**Resolution SPD-9
December 15, 2022**

RESOLUTION SPD-9. Resolution Ratifying Action of the Office of Energy Infrastructure Safety on Pacific Gas & Electric Company's 2022 Wildfire Mitigation Plan Update Pursuant to Public Utilities Code Section 8386.

**OFFICE OF ENERGY INFRASTRUCTURE SAFETY'S
FINAL DECISION ON 2022 WILDFIRE
MITIGATION PLAN UPDATE**

Figure 4.2-3: Net Change from 2021 to 2022 WMP Reporting Period (\$ Thousands)

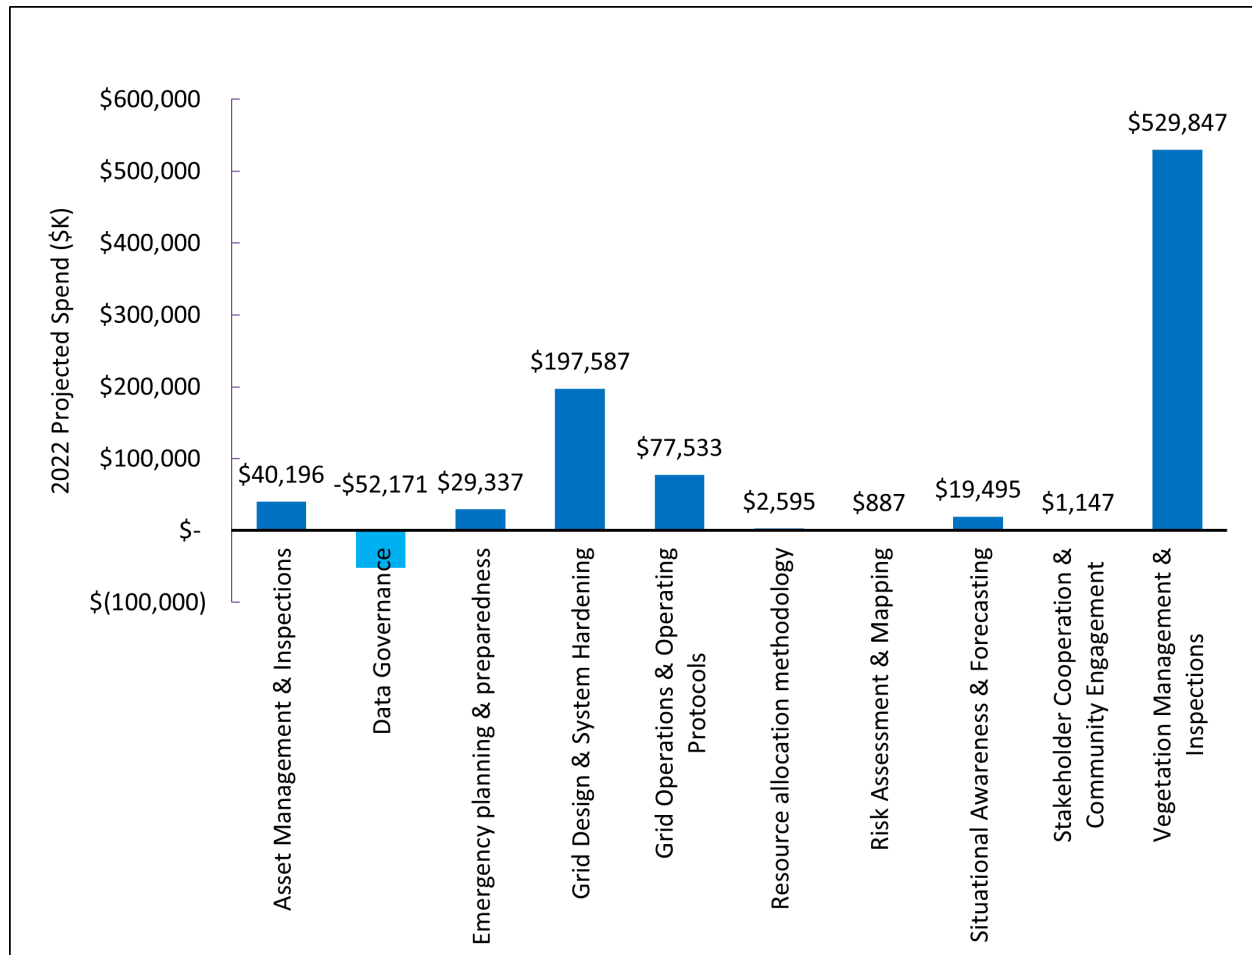
Energy Safety requested additional information about the largest changes in mitigation category spending when comparing expenditures included within PG&E's 2022 Update to expenditures projected for 2022 in PG&E's 2021 Update, as shown in Figure 4.2-3. Energy Safety asked about the following category expenditure changes:

Figure 4.2-4: PG&E Cumulative Increase in Cost to Ratepayers Due to Utility-Ignited Wildfires and Mitigation Activities (Average Increase to Monthly Electricity Bill in Dollars, 2020-2022)

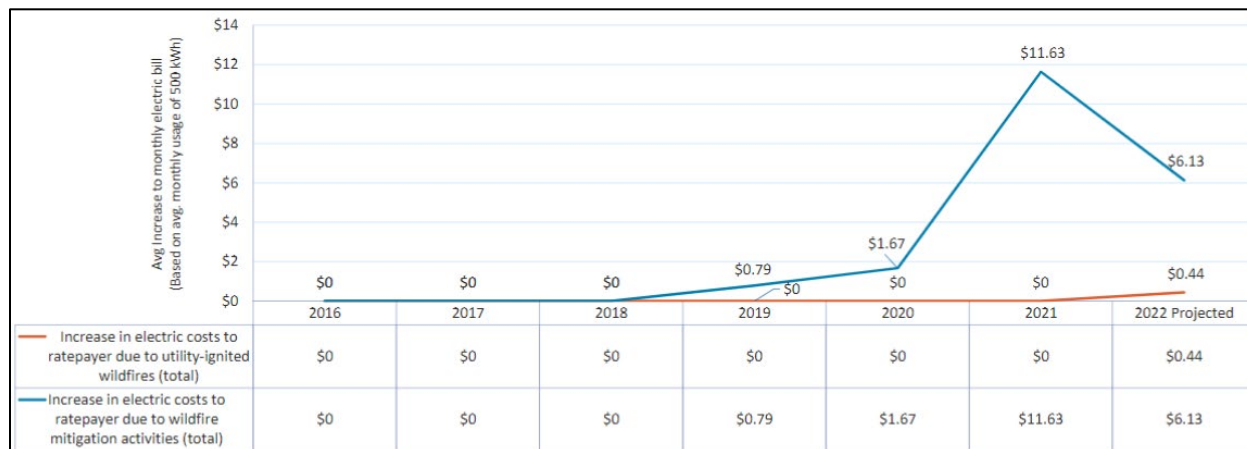
When comparing ratepayer electric costs for wildfire mitigation activities and ignitions across the large IOUs' 2022 Updates,³⁰ PG&E's increase in electric costs to ratepayers over the 2017-2022 period (Figure 4.2-4) is markedly steeper than the increase for SCE and SDG&E for the same period. Energy Safety asked PG&E to explain the large discrepancy in electric costs to ratepayers due to wildfire mitigation activities as compared to its peer utilities. In response, PG&E indicated vegetation management and inspections and grid design and system hardening are the major cost drivers of the current WMP cycle. PG&E also indicated that some of the differences in costs may be related to regulatory timing for cost recovery. Thus, SCE's

Figure 4.6.1-3: PG&E's Annual Risk Events (2015-2021)⁸²

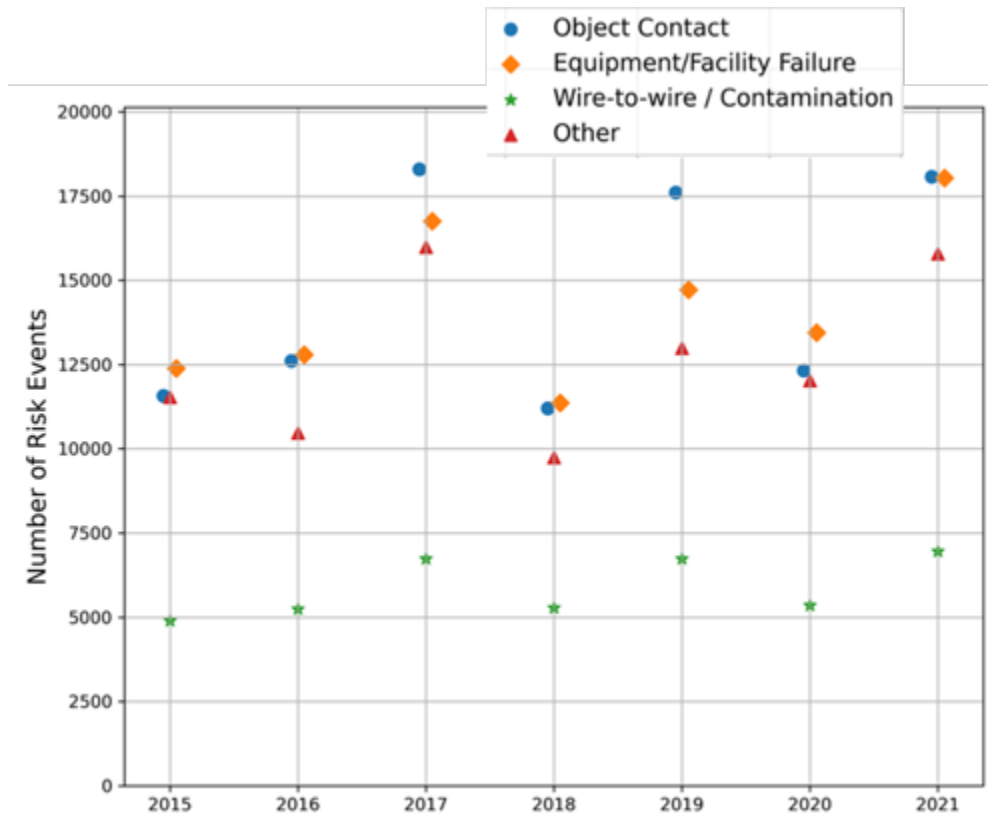
PG&E experienced an increase in overall risk events from 2020 to 2021, as seen in Figure 4.6.1-3. Particularly, ignitions caused by vegetation contact increased in both non-HFTD and HFTD areas in 2021, as seen in Figure 4.6.1-5. Moving forward PG&E must undertake and provide a more detailed evaluation demonstrating direct ties of causes to lessons learned to address the specific root causes of risk events and identify measures that will mitigate the likelihood of these risk events taking place in the future.

Figure 4.6.1-6: PG&E Wildfire Distribution Risk Model (WDRM) V2 vs. V3 Risk Scores⁹⁶

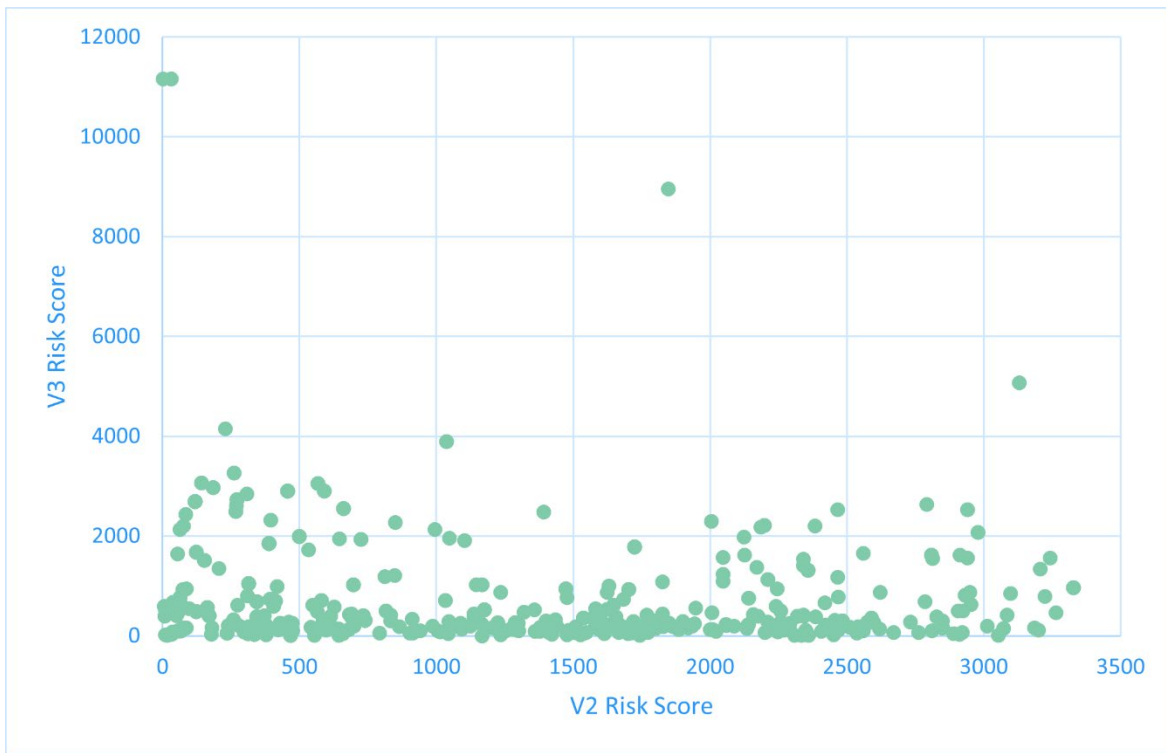
PG&E moved from Version 2 (V2) of the WDRM to Version 3 (V3). While prioritization shifts were not as drastic as those seen when adopting V2 of the WDRM, this transition did lead to a distinctive shift in prioritization. For the undergrounding projects from 2024 to 2026, no observable correlation between the V2 and V3 risk scores can be seen, as shown in Figure 4.6.1-6.⁹⁴ Additionally, when looking at all Circuit Protection Zone (CPZ)⁹⁵ risk scores, it is clear that the V2 scores lie throughout the cumulative V3 risk, with few being in the top 60 percent of cumulative risk, as shown in Figure 4.6.1-7. While Energy Safety supports improvements being made to PG&E's risk models, it is concerning that the output of risk scores continues to change in relatively drastic ways, leaving open the question of the validity not only of past models, but the current one given anticipated additional future improvements. PG&E must demonstrate an understanding of the impact of the changes made between its V2 and V3 models in order to further validate continued confidences in the risk model outputs, particularly relating to projects that may be stranded due to changes in prioritization.

Figure 4.6.4-1: Cross-Utility Maturity Comparison for Asset Management and Inspections - Large IOUs (2020-2022 Actual, 2023 Estimated)

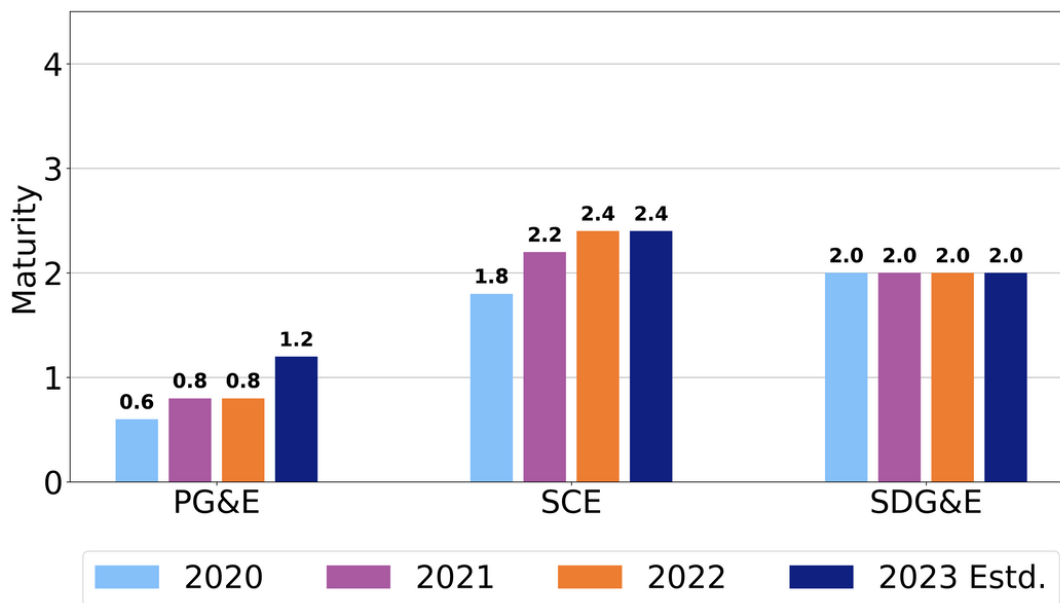
While PG&E has improved its overall maturity in the past three years, moving from 0.6 to 1.2, PG&E still remains behind its peers, as seen in Figure 4.6.4-1. Quality assurance and quality control (QA/QC) is the primary asset management and inspections capability in which PG&E is improving, as seen in Figure 4.6.4-2.

Figure 4.6.4-5: Distribution Tags based on Closing Backlogged Tag Goals

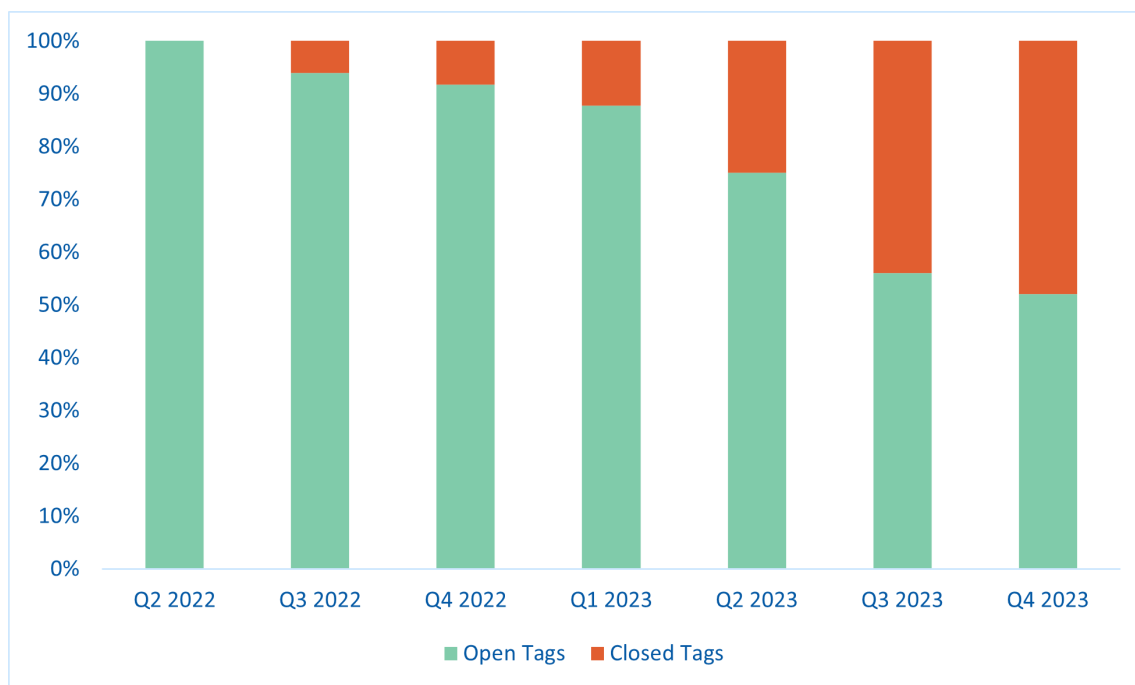
Despite providing quantitative goals to address the work tag backlog, PG&E is still creating more work tags than it is closing, as shown in Table 4.6.4-1. In the Revision Notice, Energy Safety discussed addressing the backlog by setting targets in which PG&E closes more work tags than it opens. Even with the goals provided in PG&E's Revision Notice Response, 52 percent of the open work tags for distribution will still be open at the end of 2023.

PG&E has de-escalated the critical issue RN-PG&E-22-05. PG&E provided a spreadsheet with the required information, as well as quantitative targets for 2022 and 2023. PG&E's targets for distribution are shown in further detail in Figure 4.6.4-5. It should be noted that the total number of work tags used in this figure is static based on the number of open distribution tags. Although PG&E still has a long way to go to come into compliance with GO 95 requirements and to reduce its backlog to a steady state, by committing to firm reduction targets and dispensing with the practice of continually re-starting the clock on repairs, PG&E's response to its Revision Notice is a significant step in the right direction. It should also be noted that this is not indicative of the additional tags that will be opened per quarter.

Figure 4.6.4-6: PG&E's Changes to Projected Distribution Ignitions¹⁵³

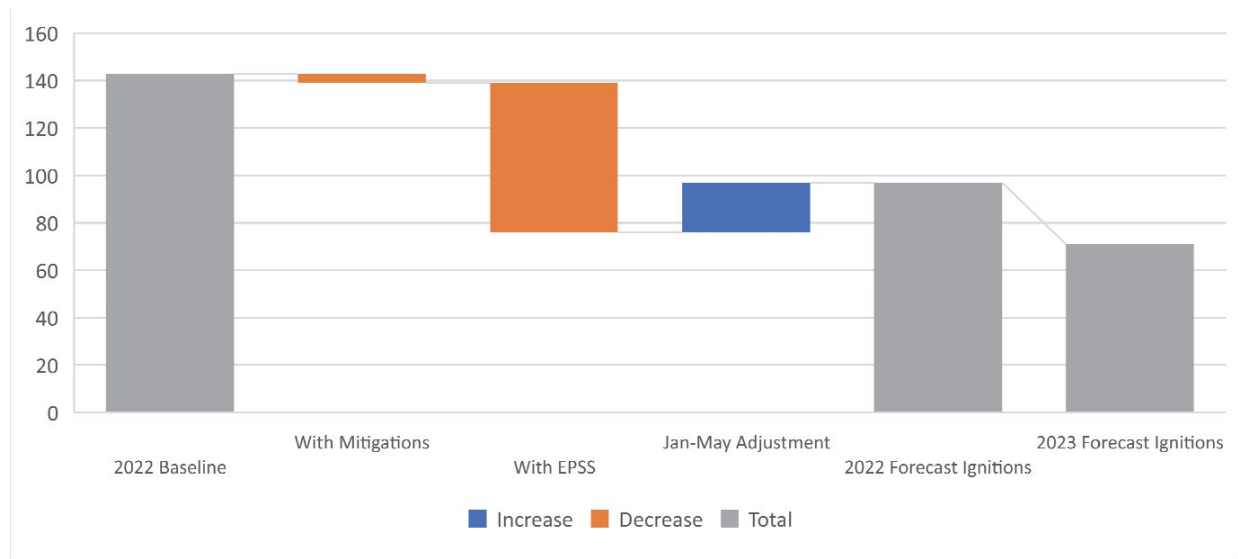
As shown in Figure 4.6.4-6, most of the decreases in the 2022 baseline ignitions are due to EPSS implementation, with minimal decrease from additional initiatives outside of EPSS. PG&E stated that, excluding EPSS, it expects ignitions to decrease by 3 percent from 2021 to 2022, and by approximately 7.4 percent from 2022 to 2023.

Figure 4.6.5-3: PG&E’s Tree-related Outage Data and Trend Line¹⁸¹

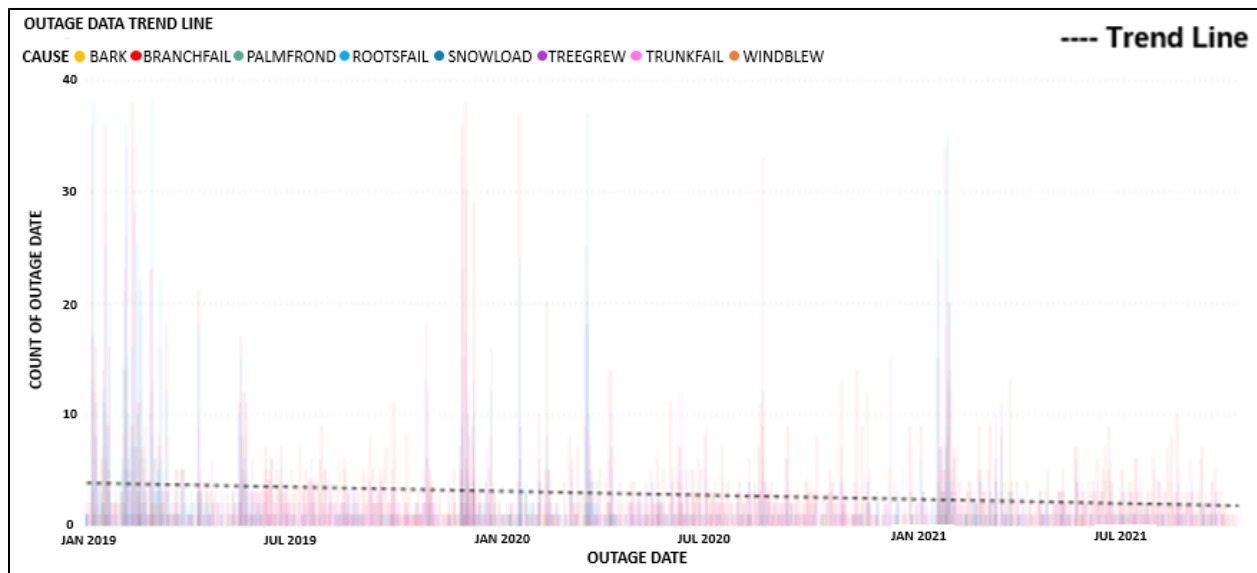
PG&E examined outage data confirmed as tree-related events and the distinct causes¹⁷⁹ of the outages since the inception of its EVM program in January 2019. PG&E’s analysis shows a decrease in tree-related events over the three-year period (Figure 4.6.5-3). PG&E acknowledges that “this data is preliminary and the decreases in tree-related causes cannot be attributed solely to enhanced clearances without further examination.”¹⁸⁰ Energy Safety’s analysis of the data it receives on a quarterly basis from PG&E does not show any trend (decrease or increase) in the number of vegetation-caused outages and ignitions on PG&E’s grid (Figure 4.6.5-4). Energy Safety’s analysis does not negate PG&E’s, nor does PG&E’s analysis negate Energy Safety’s.
